SHAKER HEIGHTS

Memorandum

Re: **Certificate of Appropriateness: 18716 Scottsdale Boulevard—Proposed Roof Replacement.** Reece Berry and Matthew Miller, property owners.

Meeting: January 28, 2026

Proposed Asphalt Shingle in Shenandoah

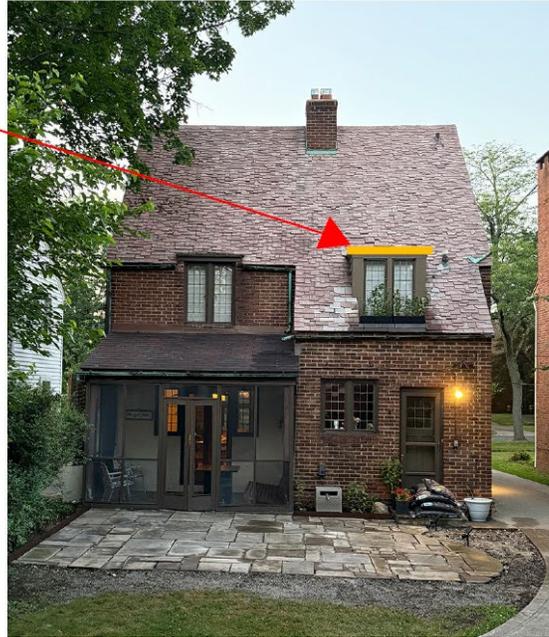
The homeowners are proposing to replace the existing asbestos shingle roof with new asphalt, Certainteed Landmark Pro Max Def shingles in Shenandoah. The homeowners will ensure that installation methods and accessory materials remain consistent with the character of the house. All roofing work will be performed by Renegade Roofing, an experienced contractor familiar with residential construction. The shingles will be installed using standard best-practice methods in accordance with manufacturer specifications.

1. The style and color of the asphalt shingle should follow the Landmark Commission's preference in a darker brown color range.
2. If the new gutter is not copper, it should be half round aluminum hung the same way as the existing gutters, in a brown finish to match the existing copper gutters.
